## **WEST MIDLANDS INTERCHANGE**

### **WRITTEN REPRESENTATION**

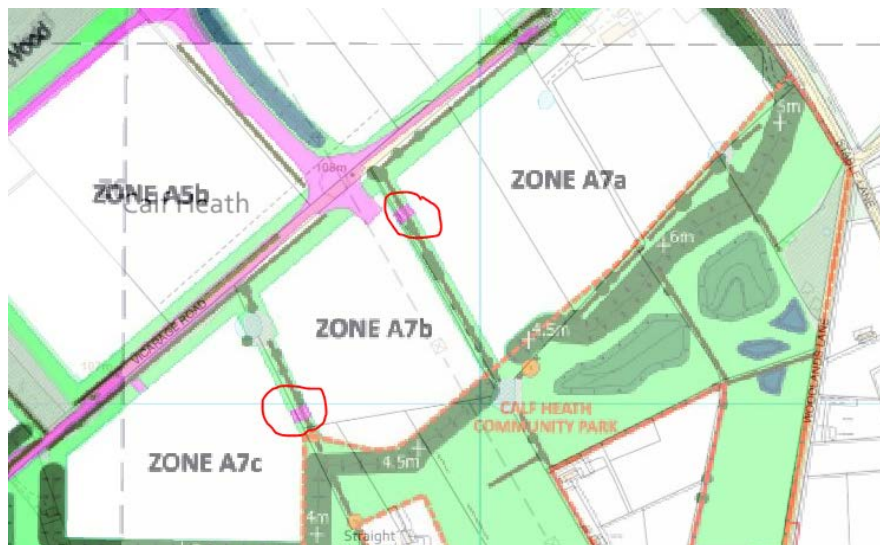
3.3. On GI / landscape plans the access into several of the zones is shown as very narrow gaps without splays etc. (e.g. Zone A7 below, circled green). This clearly does not reflect the final plan when presumably GI will be further reduced to allow access. Biodiversity loss calculations should take this into account

3.4. Of greater concern are the internal linkages/accesses between zones A7b and A7c; and A7a and A7b (circled red, below). The proposed accesses highlighted pink on the GI parameters plans cut across areas of conserved hedgerow that are proposed to be retained. It also appears that the width of these access points is far too narrow to enable HGVs to turn and pass in opposite directions.

- 3.5. Further consideration is needed on how zones A7a and A7c are to be accessed and how impacts on the hedgerow can be negated or minimised if unavoidable.
